ADDENDUM NUMBER 03

DATE: January 31, 2024

PROJECT: Cass District Library Edwardsburg, MI

PROJECT NUMBER: 22-1836

FIRST FLOOR PLUMBING PLAN
SCALE: 1/8" = 1'-0"

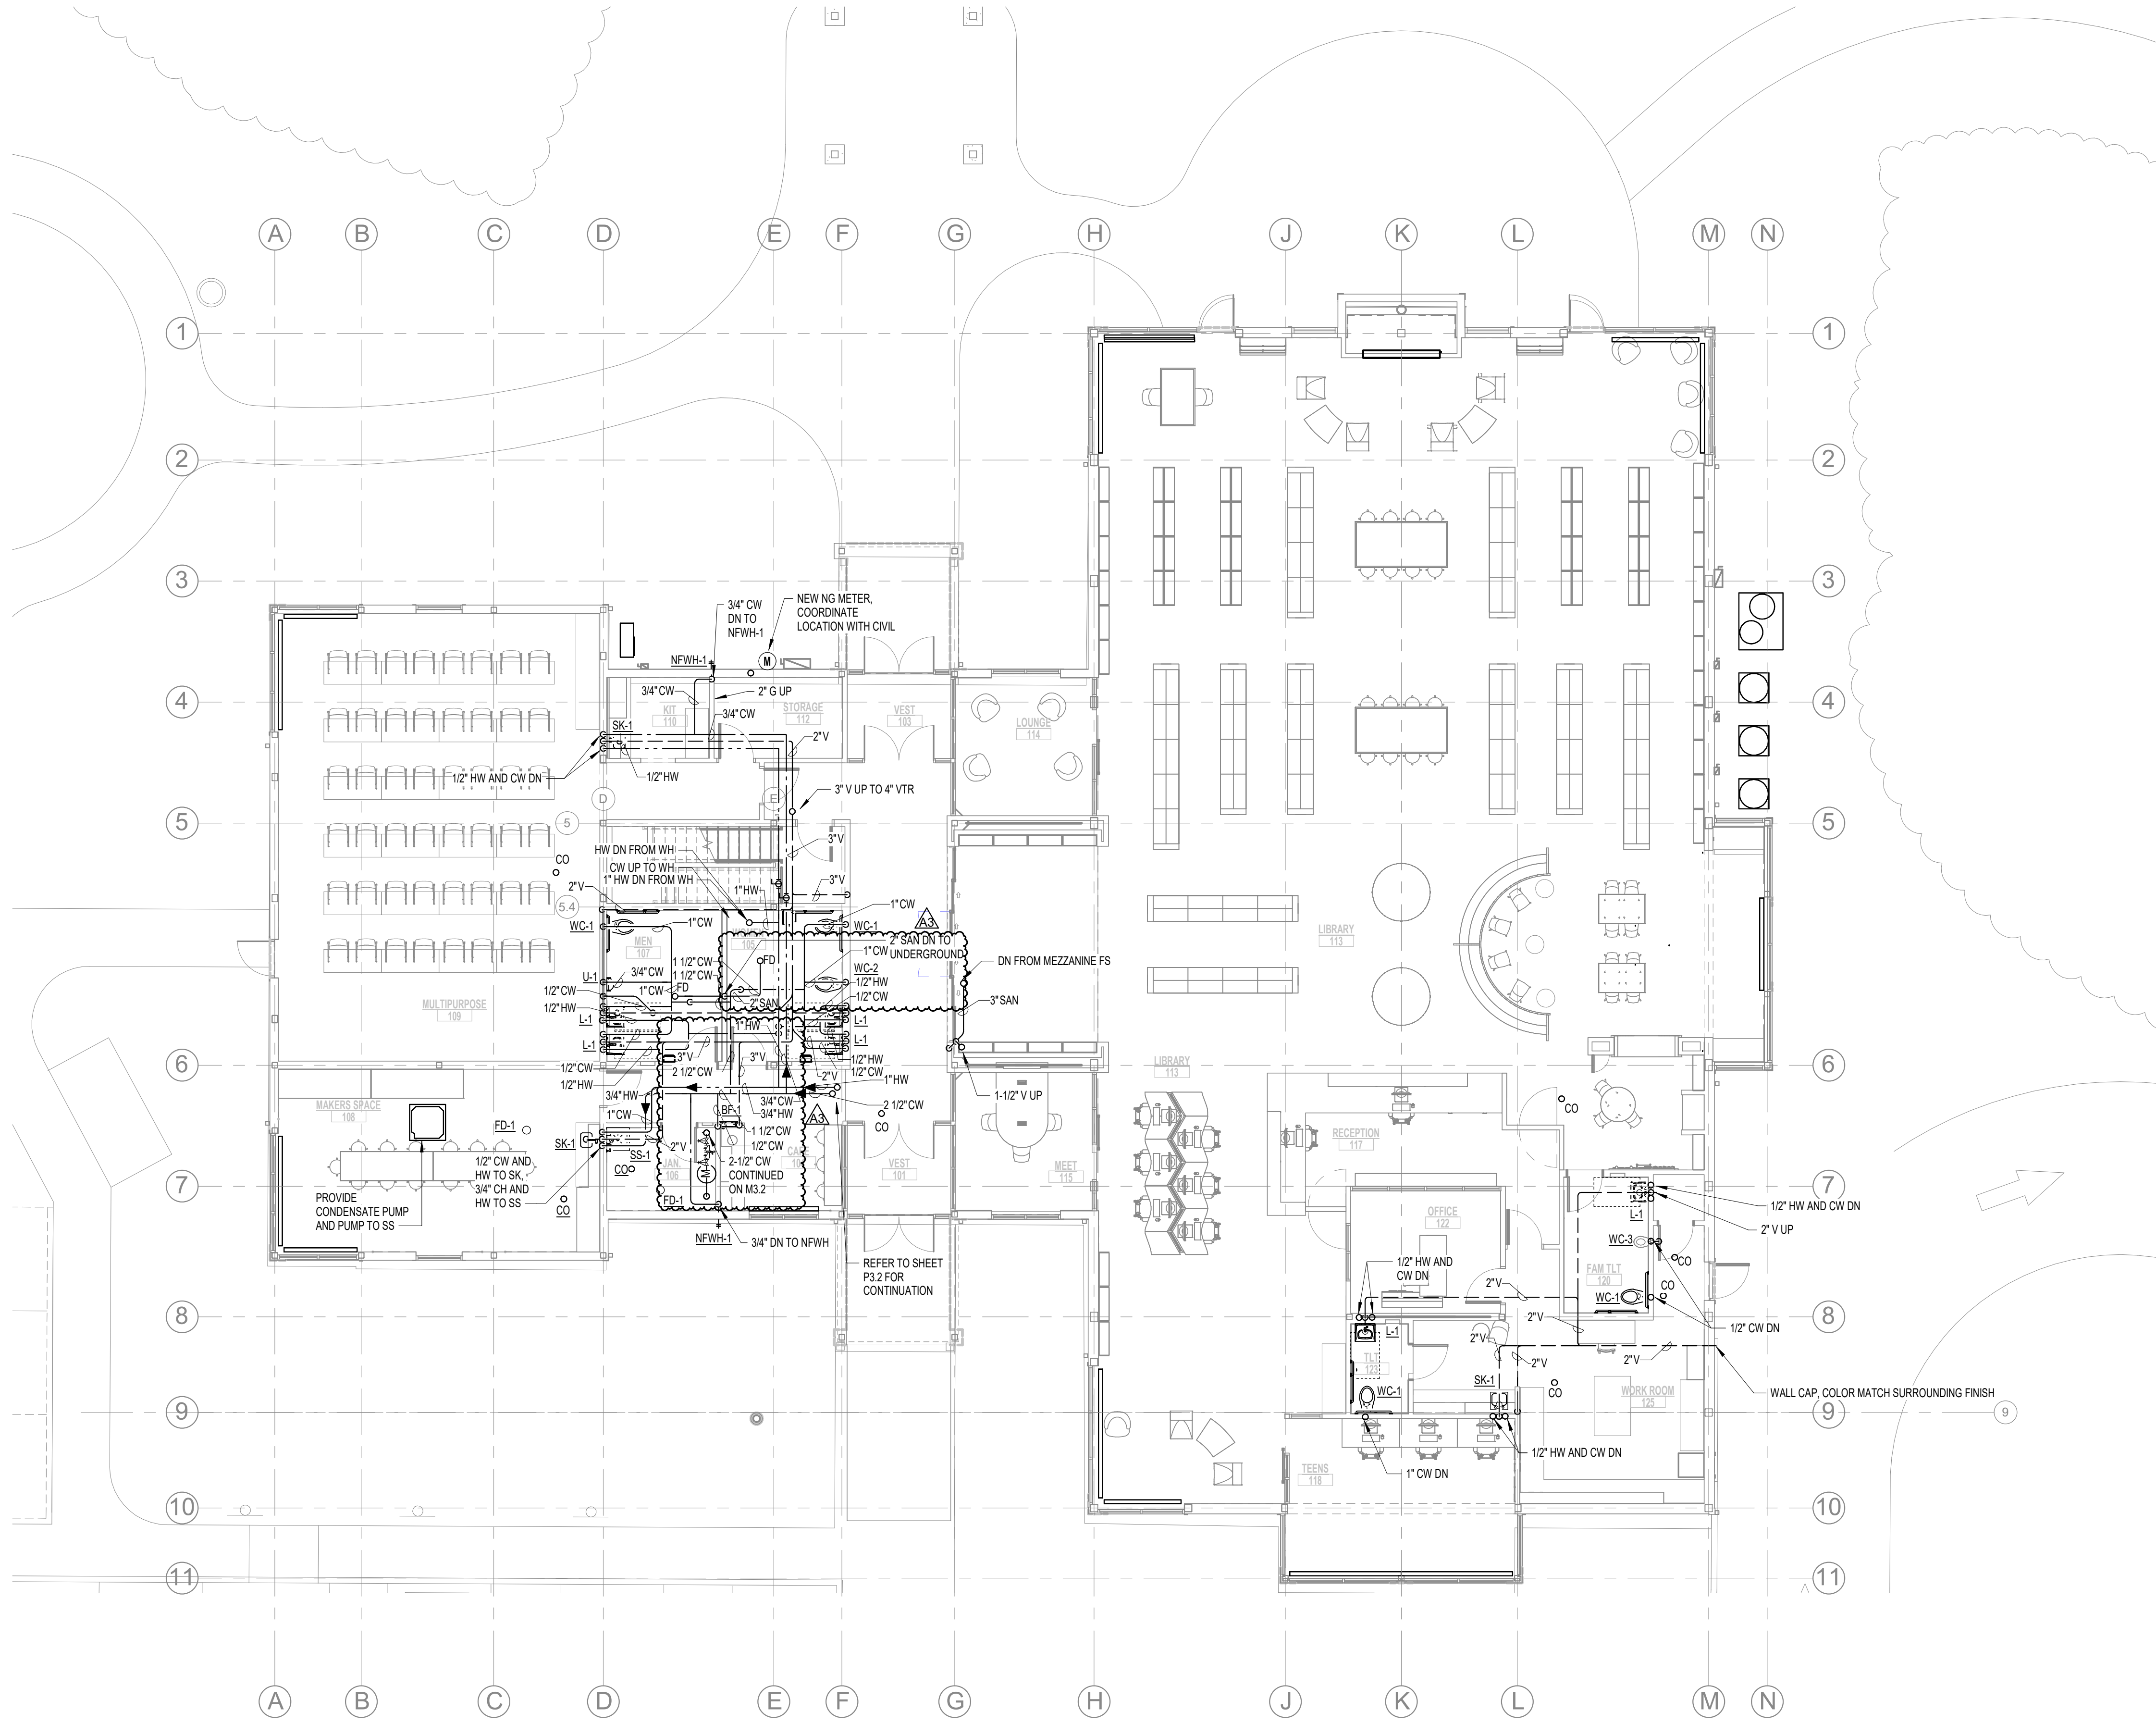
- 29. **ADD** Note to clarify sanitary down through wall between bathrooms.
- 30. **ADD** pipe size tags in hallway and bathroom entryways.
- 31. **ADD** vent pipe up from underground for BF-1 and tie into vent system.
